#### APPEAL SUMMARY

**Status:** Decision Rendered - Reconsideration of ID 24161, items 1 and 2

<b>Appeal ID:</b> 24643	<b>Project Address:</b> 1201 SW 12th Ave
<b>Hearing Date:</b> 2/24/21	<b>Appellant Name:</b> Joshua Klyber
<b>Case No.:</b> B-007	<b>Appellant Phone:</b> 5032091458
<b>Appeal Type:</b> Building	<b>Plans Examiner/Inspector:</b> John Cooley
<b>Project Type:</b> commercial	<b>Stories:</b> 6 <b>Occupancy:</b> A-2, B, E, S-1, S-2 <b>Construction Type:</b> I-B
<b>Building/Business Name:</b> NorthWest Academy - Tower Building	<b>Fire Sprinklers:</b> Yes - Basement, 1st, 2nd Floors proposed
<b>Appeal Involves:</b> Alteration of an existing structure, Reconsideration of appeal	<b>LUR or Permit Application No.:</b>
<b>Plan Submitted Option:</b> pdf [File 1] [File 2] [File 3] [File 4] [File 5]	<b>Proposed use:</b> Education Facility, Offices, Restaurant

**APPEAL DECISION****1. Determination of Tower Building as Type IB construction: Granted as proposed.****2. Determination of Tower Building occupancy as of October 1, 2004: Granted as proposed with occupant load factor of 1:100.**

**SECOND FLOOR PLAN**  
SCALE: 3/16"=1'-0"

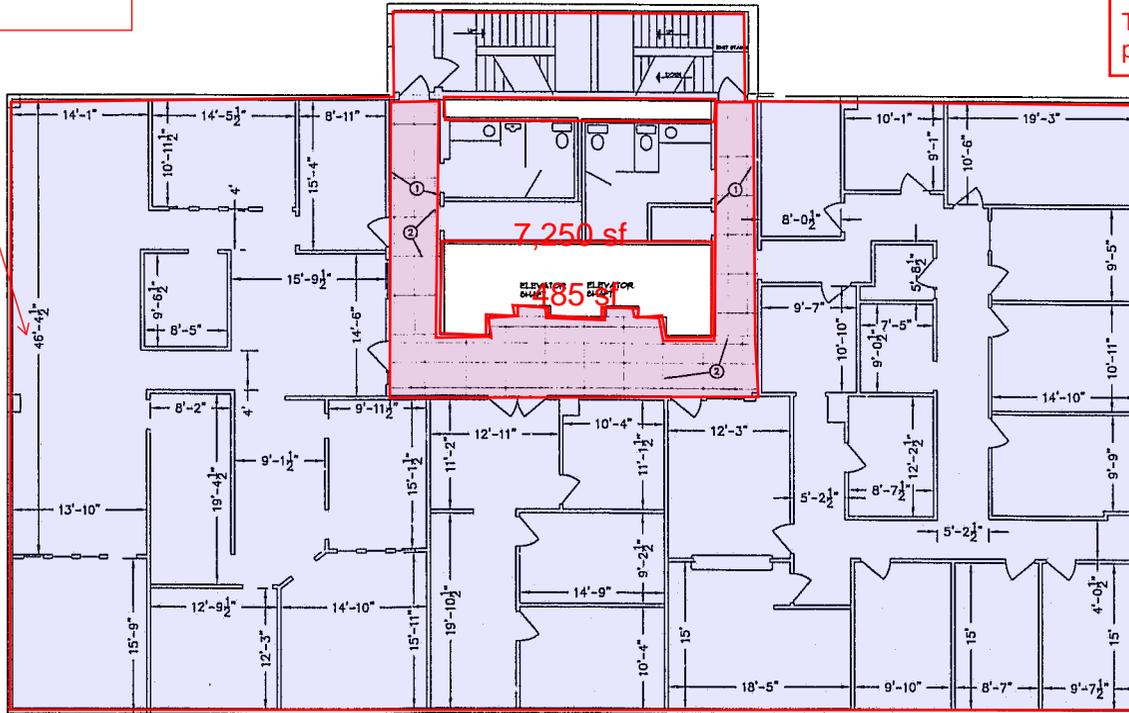
Change in areas due to miscalibration based upon this dimension. Correct dimension is 46'-4.5", not 45'-4.5".

Due to lack of labeling, areas of storage and assembly use cannot be determined.

We have assumed 350 SF of storage and 300 SF of conference room per floor.

The layouts have not changed between 2004 and present day.
